Company	Trenz Electronic GmbH
PCN Number	PCN-20251102
Title	TEB0912 FTDI EEPROM Update
Subject	FTDI EEPROM
Issue Date	2025-11-11

Affected Product
TEB0912-03-*

#1 FTDI EEPROM content: AMD-Licence key

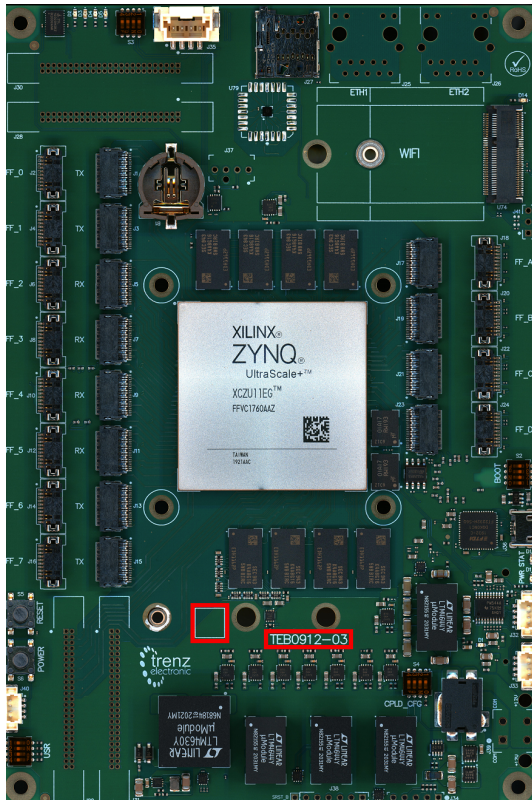
Type: Firmware change

Reason: Change according to FTDI programming method released by AMD with Tool Version 2022.2 and newer (UG980 - Chapter: Programming FTDI Devices for Vivado Hardware Manager Support).

Impact: AMD Licence key is compatible with AMD Tools greater and equal 2017.1 release. Programmer will be identified as 'Xilinx/TExxxxxxxxx' where the x is the serial number of the board filled with leading zeros, see [AMD FTDI JTAG Programmer#IdentificationofAMD/TrenzLicence](#)
